**2<sup>nd</sup> Further Information**

**Temporary Warehouse (Excluding Dangerous Goods Godown) and  
Associated Filling of Land for a Period of 3 Years in "Agriculture" Zone,  
Lot 973 RP (Part) in D.D. 107, Fung Kat Heung, Kam Tin, Yuen Long, New Territories**

**(S.16 Planning Application No. A/YL-KTN/1163)**

Response to Comment

Annex I – Photographic Record Showing the Existing Drainage Facilities on the Site

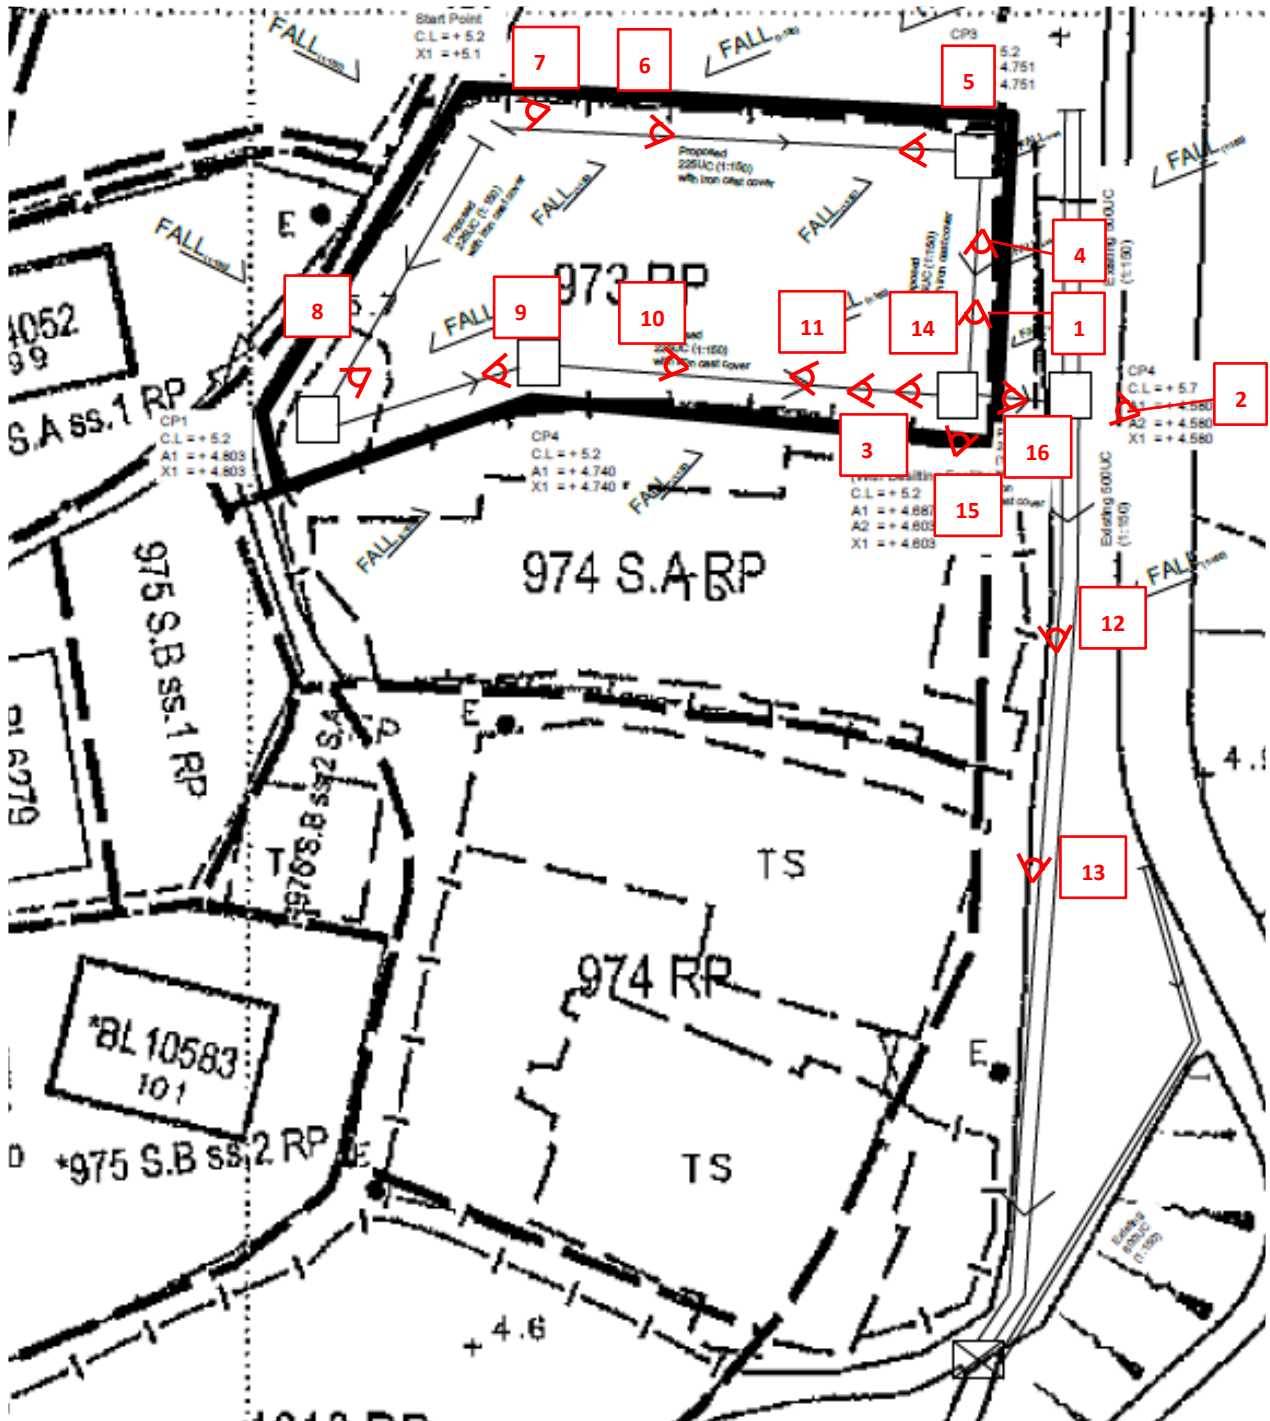
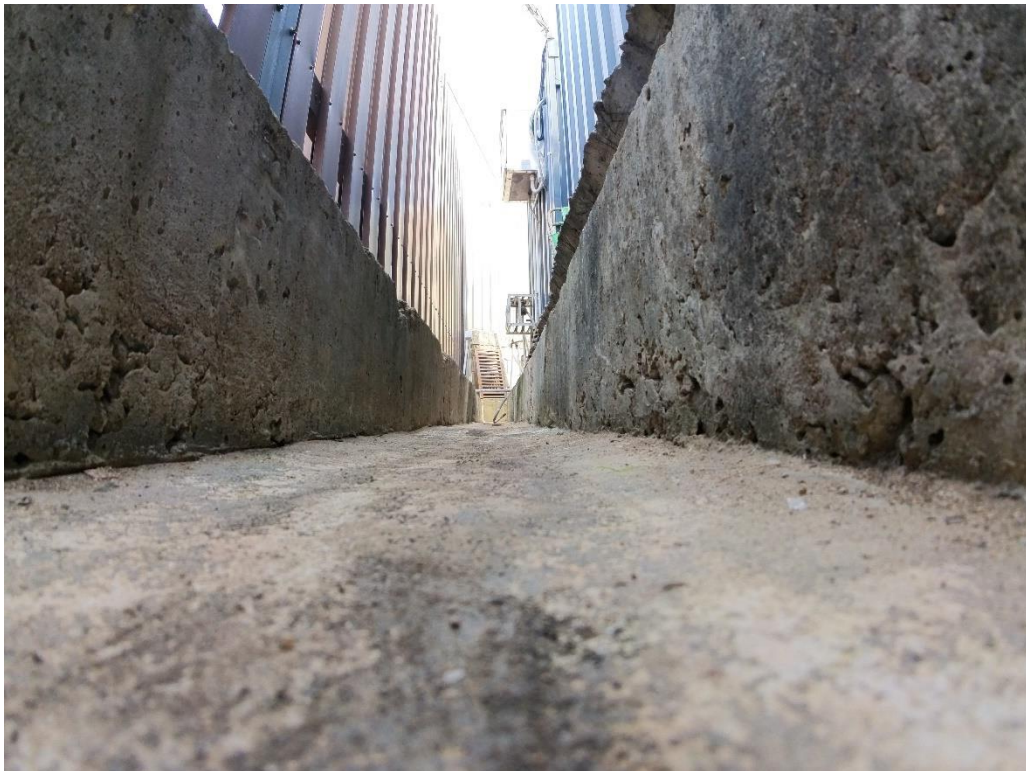
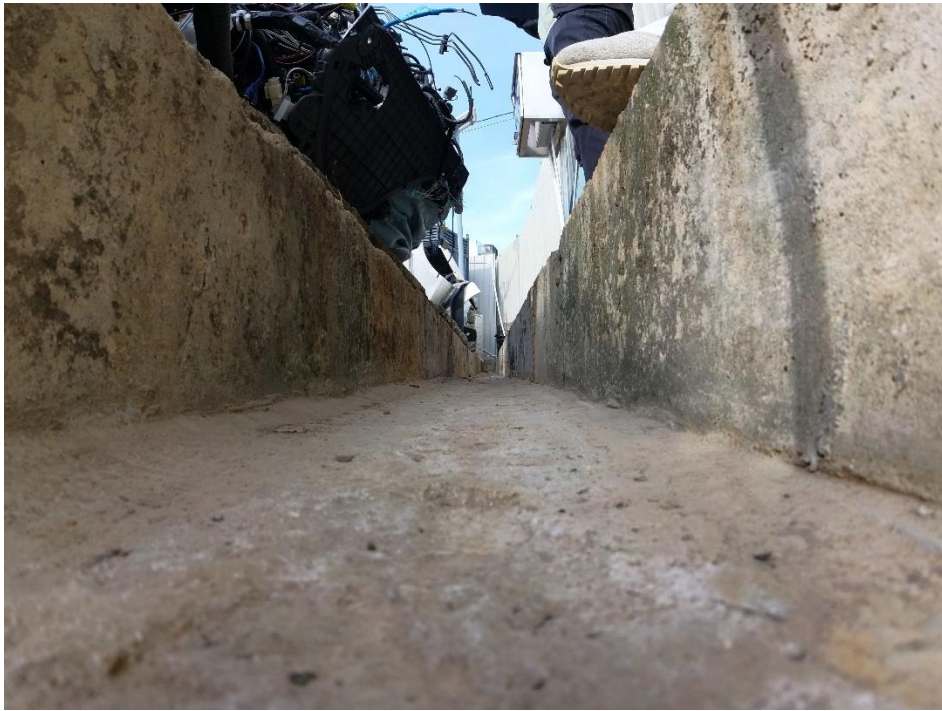
Departmental Comments		Applicant's Responses
<b>1. Comments of the Chief Engineer/Mainland North, Drainage Services Department (CE/MN, DSD) (Contact Person: Ms. Jessica KWAN; Tel: 2300 1444)</b>		
(a)	The applicant should supplement site photo(s) to show condition of existing 225 mm (W) surface channel at the downstream of the catchpit (with sand trap) CP2.	Please refer to the updated photographic record showing the existing drainage facilities on the application site ( <b>Annex I</b> ). Site photos showing the existing condition of the 225 mm (W) surface channel at the downstream of the catchpit (with sand trap) CP2 are provided.
